EGG-SSDC-5288

HUMAN FACTORS ENGINEERING EVALUATION OF  
THE ADVANCED TEST REACTOR CONTROL ROOM

M. P. Boone  
W. W. Banks

Figure 34. Temperature mode select switch. (If this switch is moved to the three-element mode, it may possibly scram the plant.)

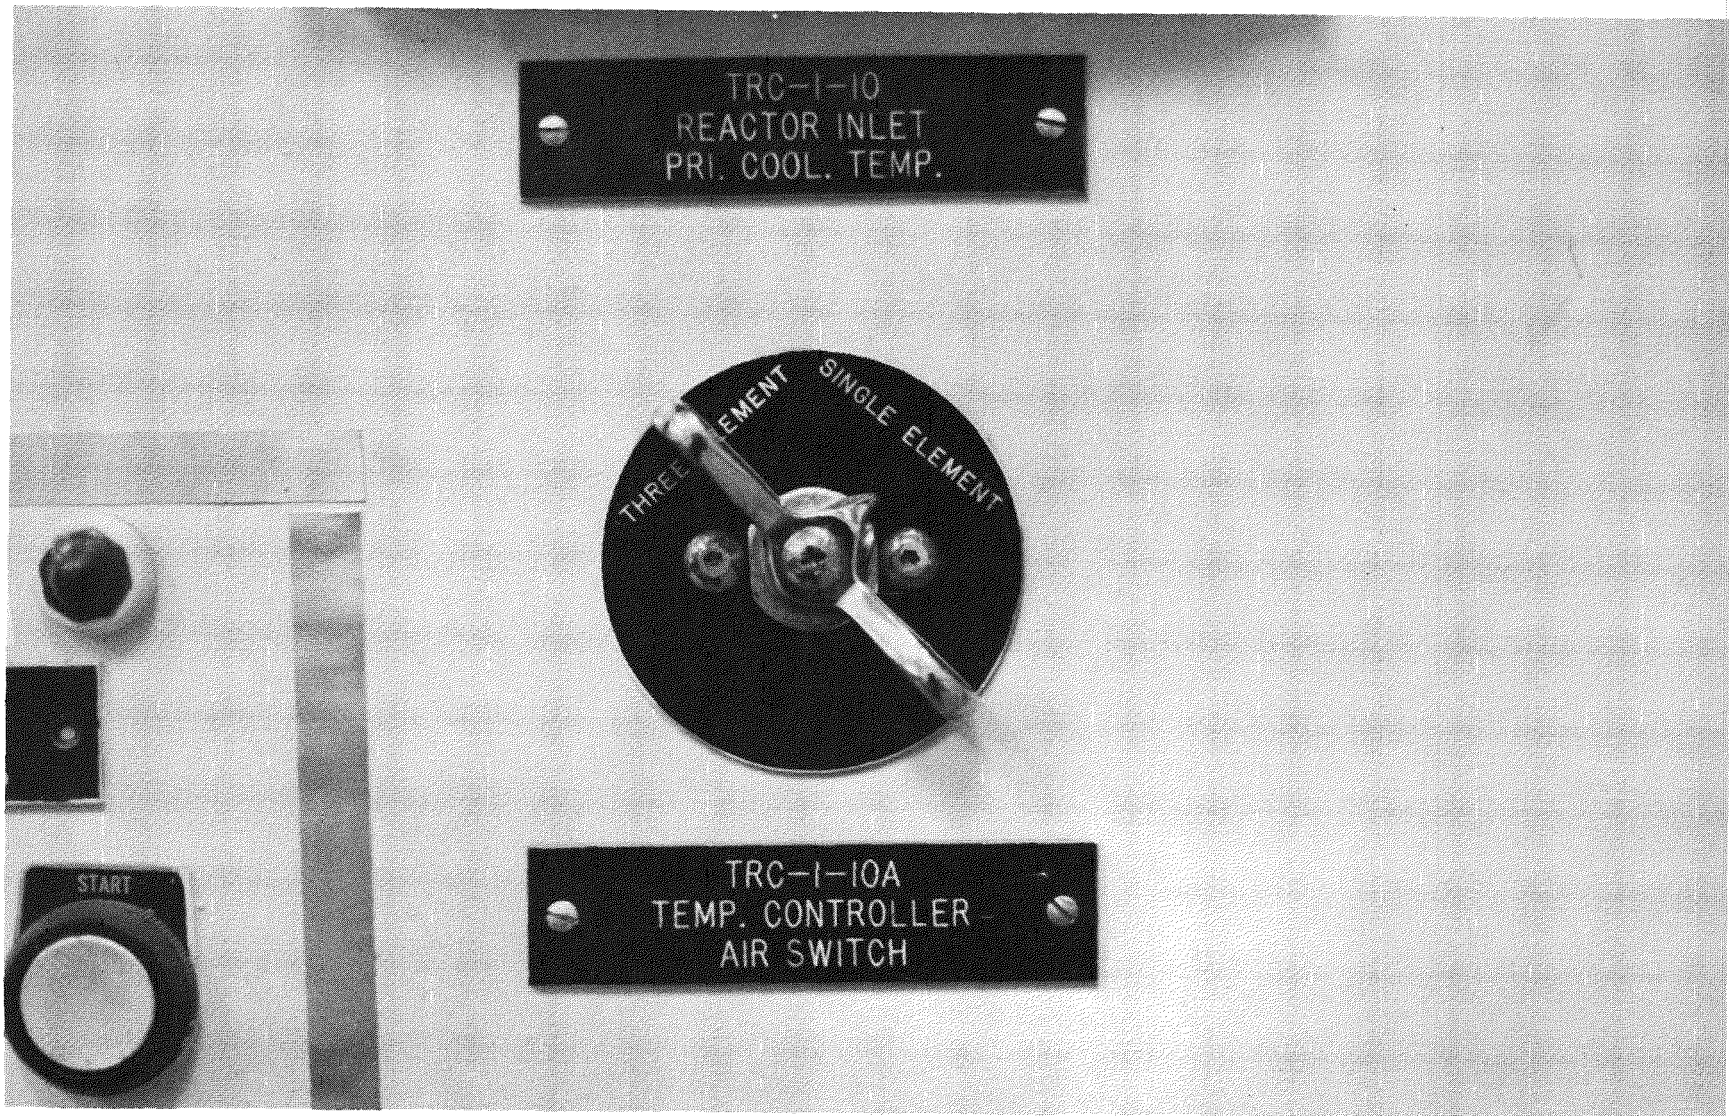
There is a two-mode (WRC-2-1) butterfly hand switch (see Figure 34) which is part of the secondary coolant (water) system. The extreme left position for this switch is never used. In fact, if the switch were placed in this position, either accidentally or intentionally, a SCRAM would occur. Since this particular element is never used and offers undesirable potential, it should be electrically blocked from the system and the switch removed from the panel.

Figure 35. Auto sump switch.

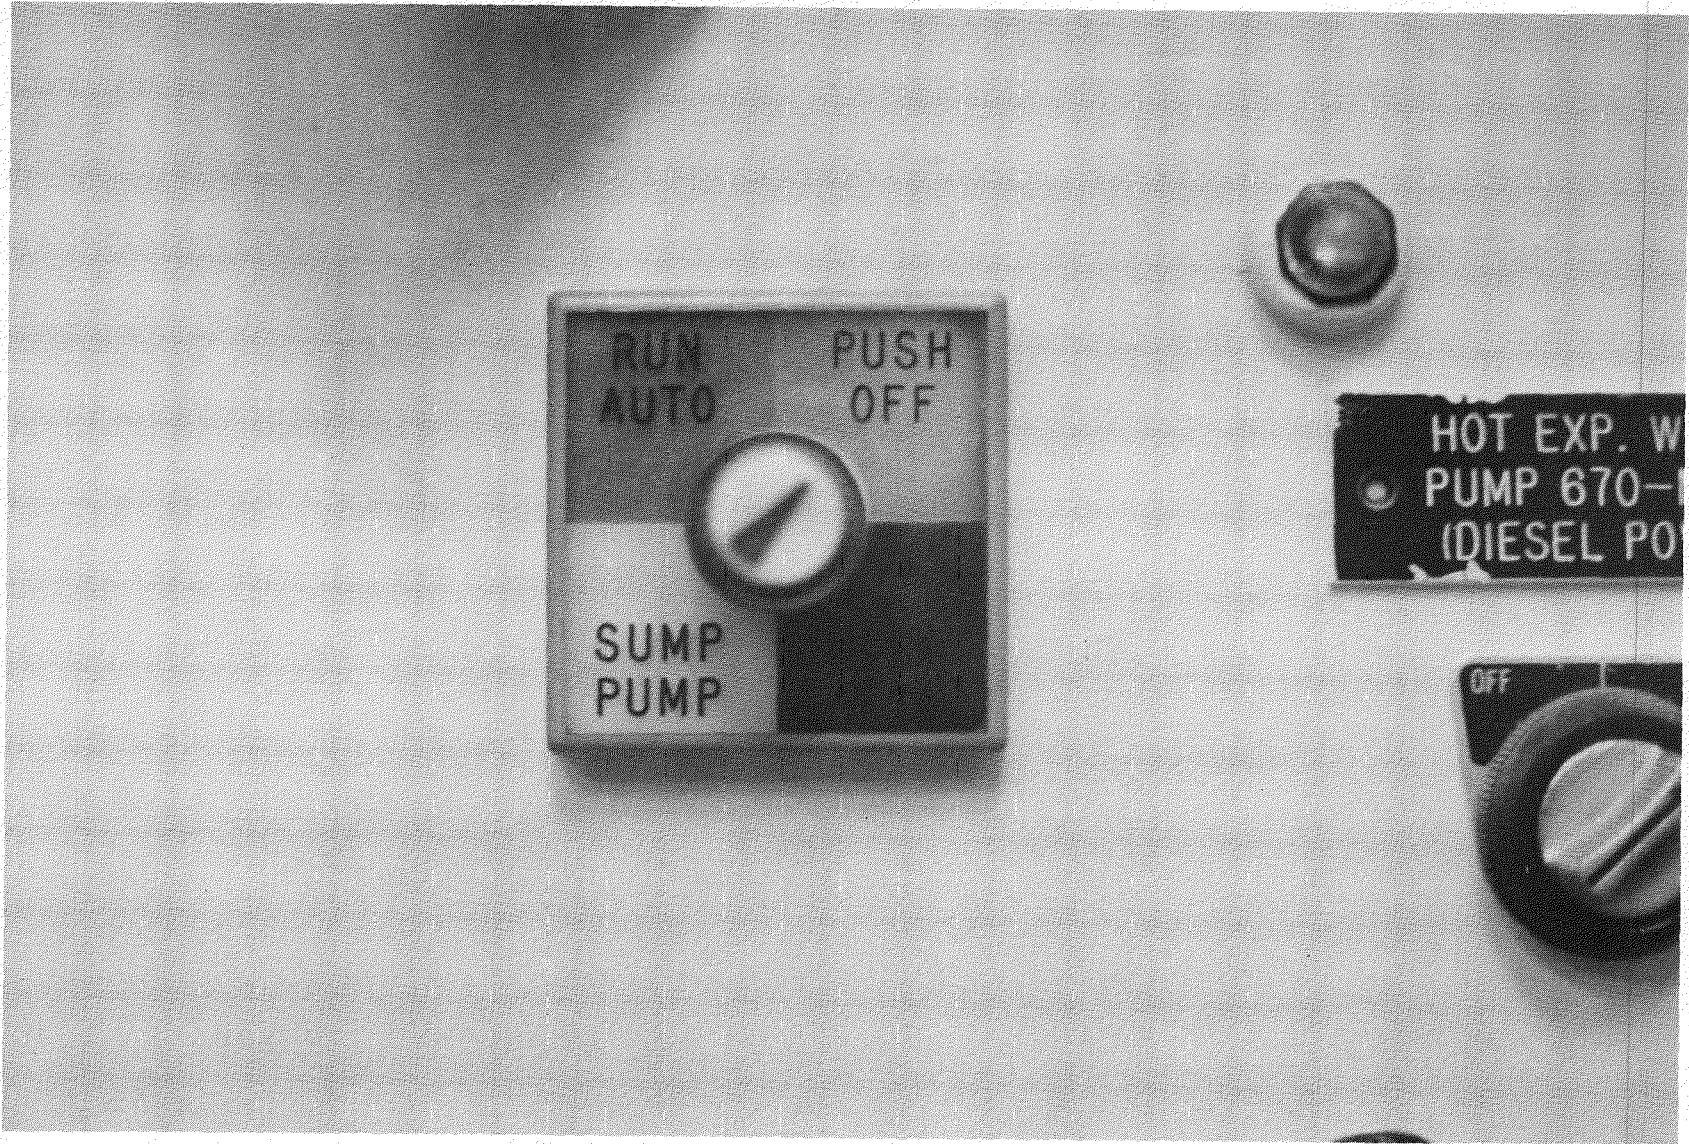
The auto-sump pump switch (see Figure 35) which is part of the heat-exchange system gives the impression of being a four-position selector, but is a two-position control. The upper-right quadrant of the switch is for the "off" position and the left-lower quadrant is used as a name label. The operation of the switch involves a pulling-and-turning motion simultaneously. Single-motion switches are preferred to multimotion, except where the likelihood of inadvertent operation is high and consequences are serious.

Figure 38. Cooling tower fan controls. (The labels "fast" and "slow" are misleading. "Increase speed" and "decrease speed" would be more appropriate.)

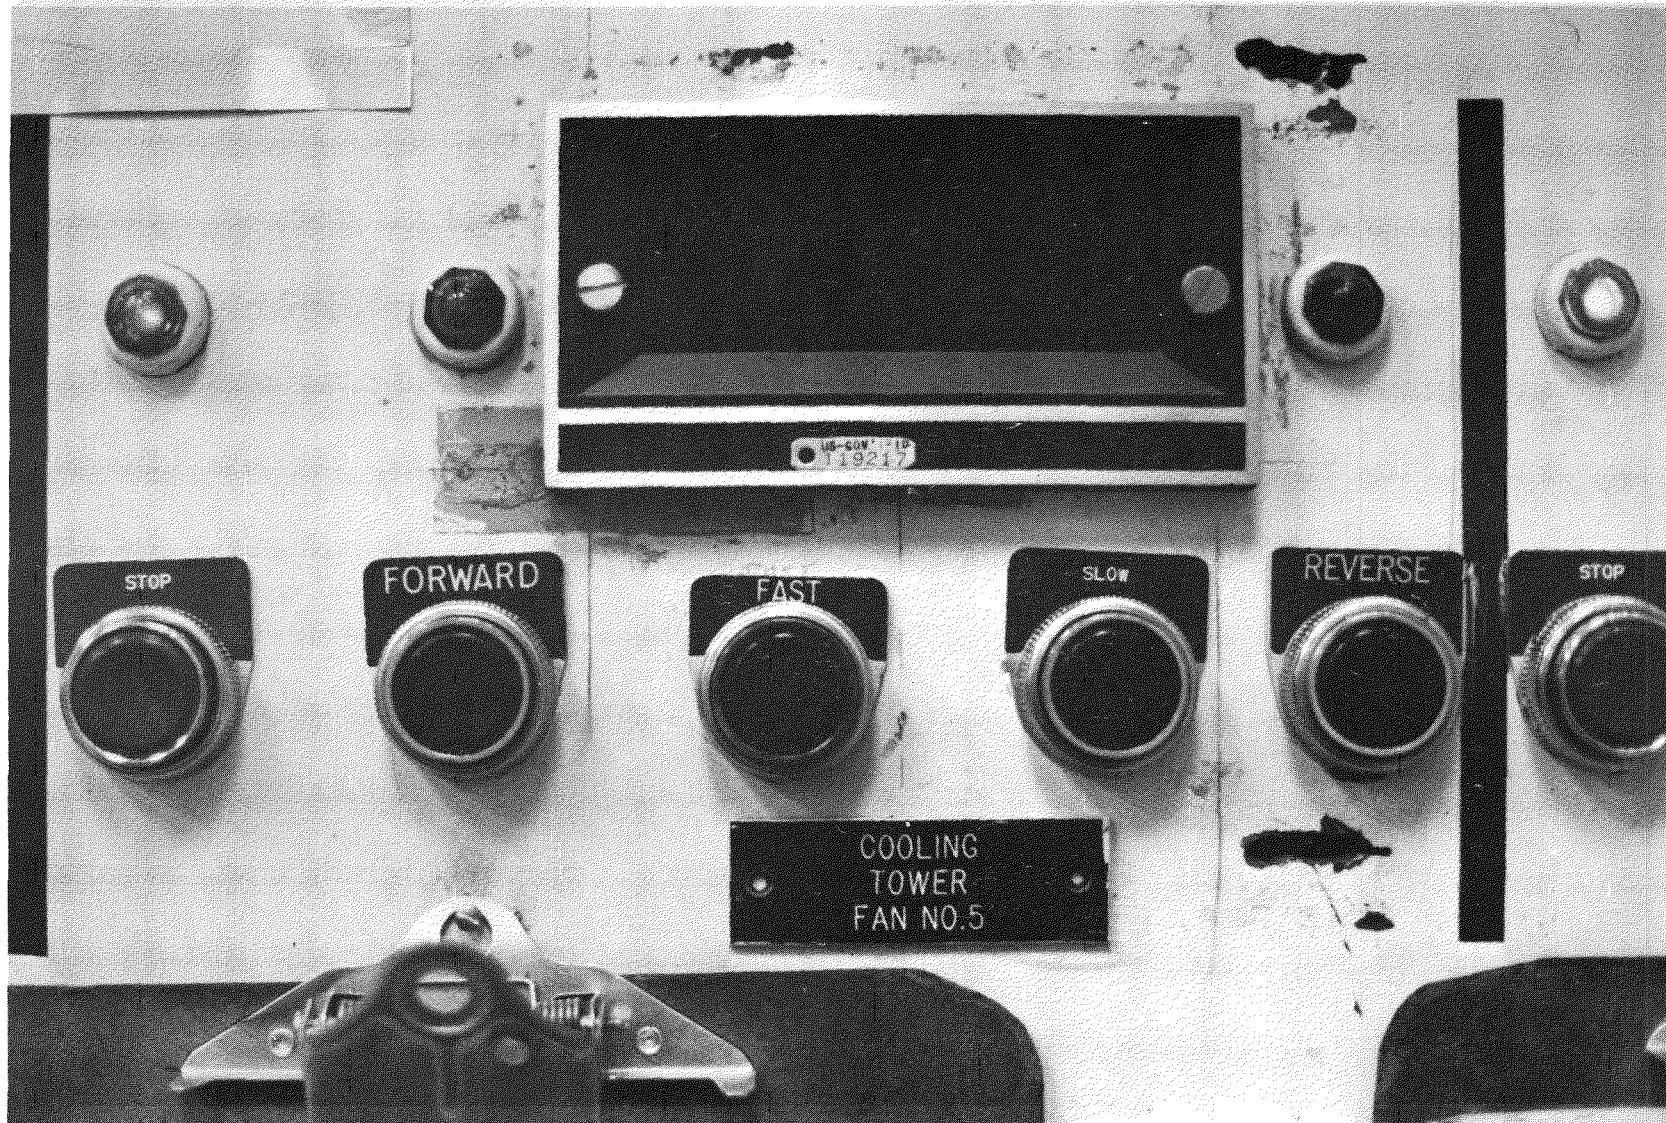
The labeling of the secondary cooling fan controls is confusing (see Figure 14). The word "fast" is used to mean increase fan speed, "slow" is used to mean decrease fan speed. The words "increase" and "decrease" would be more appropriate. But a more pressing problem than the labeling is the push-button controls themselves. Fan speed (Figure 14) is difficult to control using the push-buttons. When a control button is pushed, the fan will often increase or decrease in speed more (overshoot) than is desired by the operator. We recommend that the rheostat which controls the speed be equipped with a rotary knob and located on the panel face. This would allow the fan speed to be controlled with much more precision.
